ENVIRONMENTAL PROTECTION DIVISION

Second Addendum to 2023 Ambient Air Monitoring Plan

New Site in Atlanta

New site details: Empire Blvd

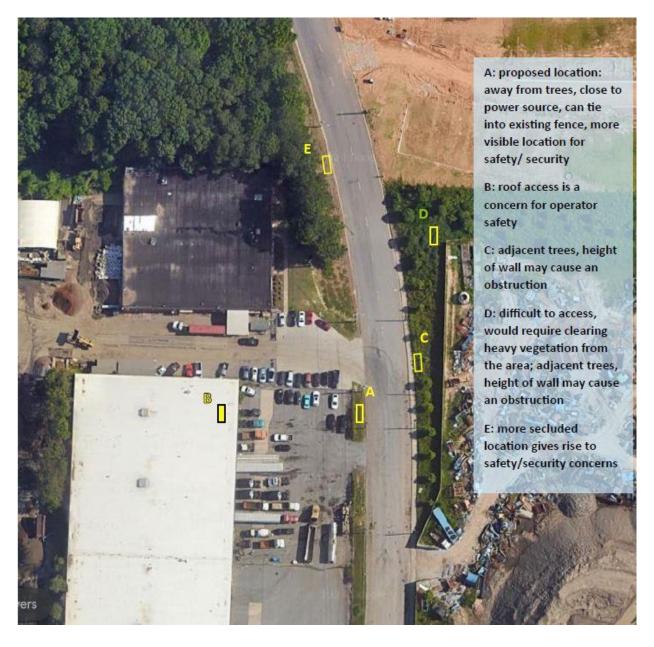
The ambient air monitoring equipment's proposed location is situated between two parking lots. The ambient air monitoring equipment would include emissions from vehicles entering and leaving the parking lots, including large trucks, potentially leading to inaccurate and unreliable lead sampling and lead data. Additionally, the ambient air monitoring equipment would be located near power lines, which would further result in inaccurate and unreliable lead sampling and lead data.

Due to logistical limitations, this is the most feasible location for the ambient air lead monitor. EPA has approved GA AAMP's choice of location and the GA AAMP's Quality Assurance Project Plan for this project, ensuring quality ambient air data will be collected and used by EPA.
